## Reply to Referee #2' s comments

**Title: A flux tower site attribute dataset intended for land surface modeling**

**No.: essd-2024-77**

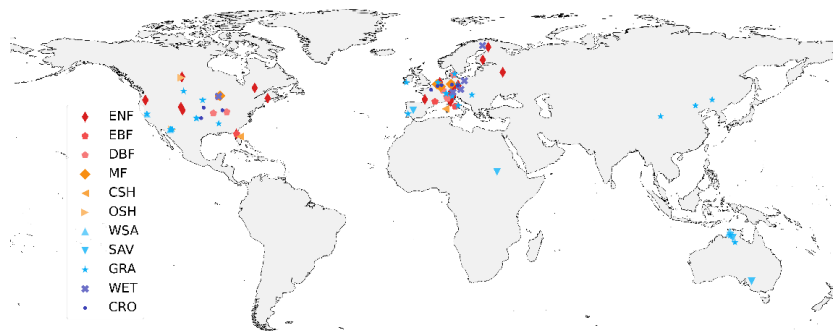
**Comment 7 (L76):** *Why are LAI and canopy height included in the four most important attributes, even though they aren't required as inputs for many LSMs? Soil depth, however, is not mentioned, which can strongly impact model outputs and is required by many LSMs as well.*

Thanks for the reminder. Soil depth is indeed an indispensable variable in LSMs. Therefore, we have added the site soil depth data to the attribute dataset. The dataset is available at <https://doi.org/10.5281/zenodo.12596218>. We have also updated the graphs and related text describing the attribute data.

**Soil bulk density, organic carbon concentration, and depth**

Soil bulk density, organic carbon concentration, and depth data are sourced from site descriptions in literature, regional networks, and AmeriFlux BADM file. Specifically, soil bulk density was collected at 37 sites, soil organic carbon concentration at 23 sites, and soil depth at 31 sites. The observation depth was provided for soil bulk density at 32 sites and for organic carbon concentration at 22 sites. Despite the scarcity of site-observed data for the three soil attributes, we have included them in the final dataset. For site-specific studies, they can provide useful references for researchers.

**Origin (Figure 2):**

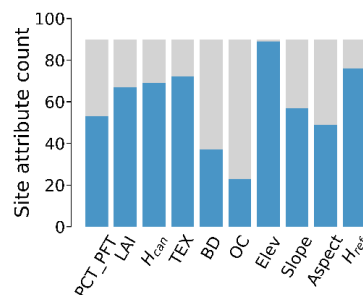
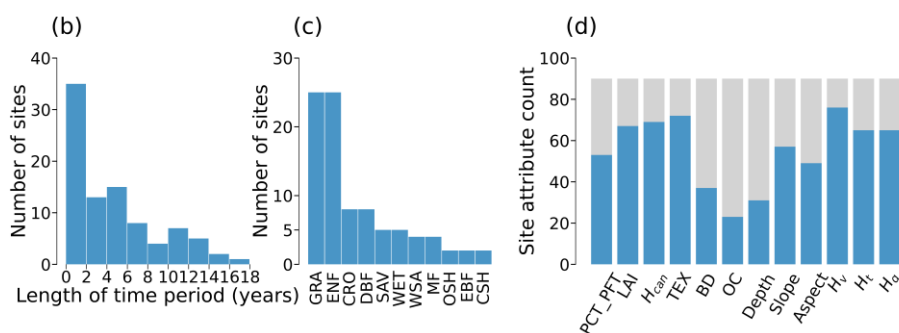
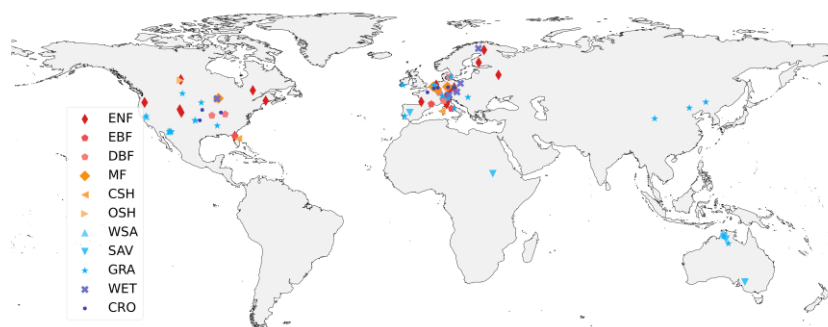
***Comment 2:** Regarding the soil attributes that were included for the sites, I'd be interested why the authors do not mention soil depth. I'm aware that soil depths measurements are generally not available for the sites, but it is an important variable in many LSMs. Even if it is obtained from global gridded datasets, it could still be useful to include in this dataset. Another variable, which was not included, is the measurement height of air temperature. As this is required in several LSMs and is not always the same height as the measurement height of wind speed, I think it would be useful to include the air temperature measurement height as well or explain why it was not included.*

**Comment 23 (Figure 2):** Don't you mean "number of years", not "site numbers" in the caption for (b)? In (d), is this the actual number of sites or the percentage? The name Hcan is a little confusing, as you talk about sensible heat flux as H above and here H is height.

**Response 2:** We totally agree with your suggestion. We have added soil depth as well as the measurement heights of air temperature and humidity to the attribute dataset. Please see Responses 7 and 12 for the processing of soil depth, and Response 13 for the processing of measurement heights of air temperature and humidity.

“(d) Number of collected site-observed attribute data for PCT\_PFT, maximum LAI (LAI), mean canopy height ( $H_{can}$ ), soil texture (TEX), bulk density (BD), organic carbon concentration (OC), and soil depth (Depth), slope, aspect, and reference measurement height (Wind:  $H_v$ ; Air temperature:  $H_t$ ; Humidity:  $H_q$ ).”

**Response 23:** Thanks for your suggestion. In Figure 2 (b), the vertical coordinate is the number of sites, and the horizontal coordinate is the number/length of years.

H (sensible heat) and canopy height ( $H_{can}$ ) do tend to be confusing, so we plan to change the abbreviations for sensible heat and latent heat to Qh and Qle in the manuscript submission after discussions, and the abbreviation for canopy height will remain the same. Thank you very much for your suggestion.

**Revised (Figure 4):**

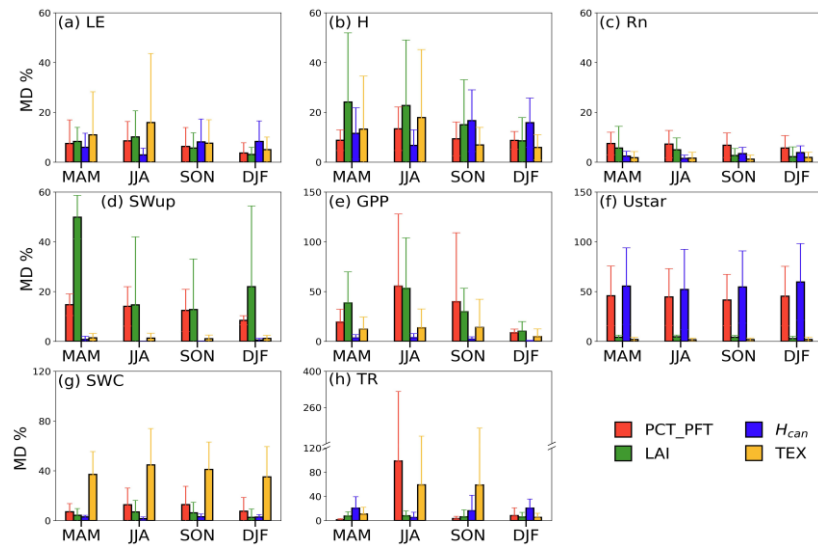
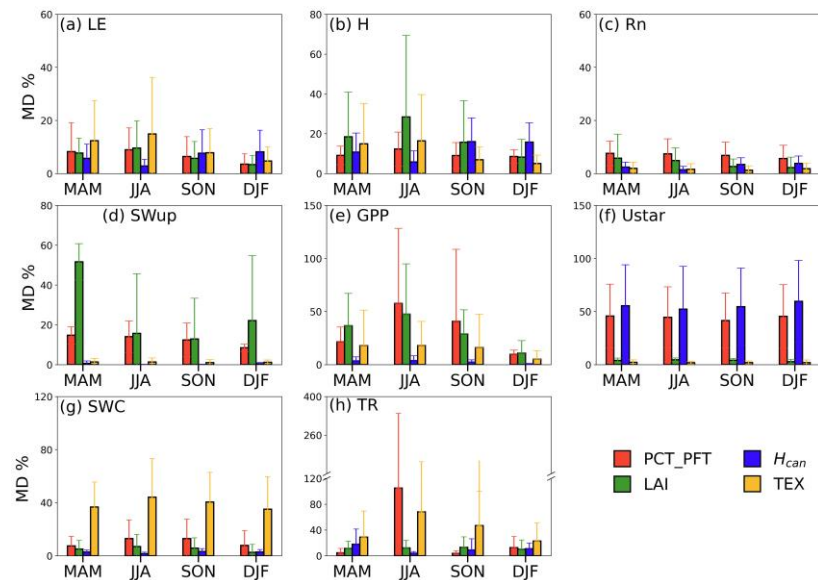
**Comment 19 (L224):** *Why only the first year and not all available years at the sites? One year could be*

**Response 19:** Thank you for your suggestion. It's true that using only one year of data for SPIN-UP is not quite right. Therefore, we have changed the SPIN-UP approach. The new scheme loops the atmospheric forcing data for each site's observation period until it reaches 50 years.

We redrew the pictures associated with the model results (including Figure 4, Figure 5, Figure 6, and Figure 7). Overall, these figures don't change much. And the relevant MD% values in this paper are modified. The comparison before and after modification is as follows:

Origin (Figure 7):

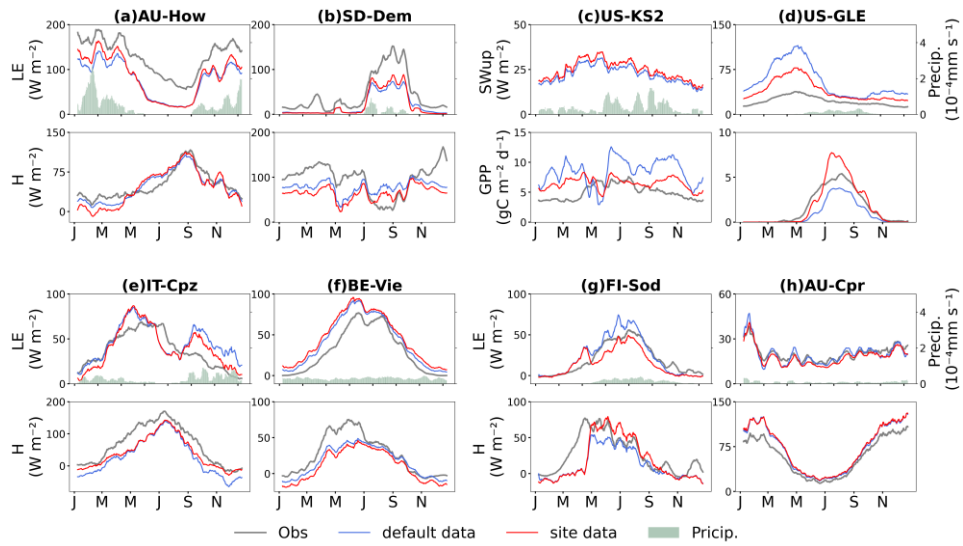
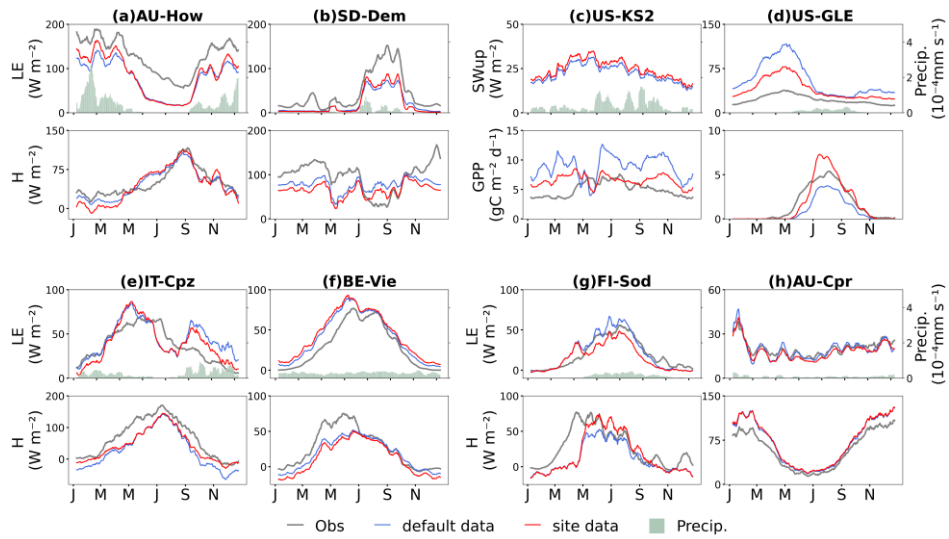
***Comment 3:** Some of the Tables and Figures could be improved by organizing sites in the same order for the different variables that are shown or to show the selected variables for all the sites. For example, Table 2 and Figure 7 could be made clearer.*

**Comment 31 (Figure 7):** *Why do you show SWup and GPP at 2 sites only and don't show the LE and H there? Also, it doesn't seem to show observations for SWup at US-KS2. Why show that variable at that site, if observations were not available? Why were these specific 8 sites chosen for the figure (and not all 36 sites) and why don't you show LE, H, GPP and SWup at all the selected sites?*

Figure 7 is intended to illustrate that the impact of attributes is substantially associated with precipitation. We intentionally chose two typical sites for each attribute and formed a contrasting effect to illustrate the important role of precipitation. Therefore, only 8 sites are ultimately shown. We have added this information to the description of Figure 7. Please refer to Response 31 for specific details.

**Response 31:** Thank you for your question. I'm sorry for the confusion. In the modeling assessment of attribute data, four attributes were selected, and Figure 7 shows two typical sites for each attribute (which can be contrasted to highlight the important role of precipitation). We have added this information to the description of Figure 7.

Figure 7 is intended to illustrate that the impact of attributes is substantially associated with precipitation. We intentionally chose two typical sites for each attribute and formed a contrasting effect to illustrate the important role of precipitation. Therefore, only 8 sites are ultimately shown.
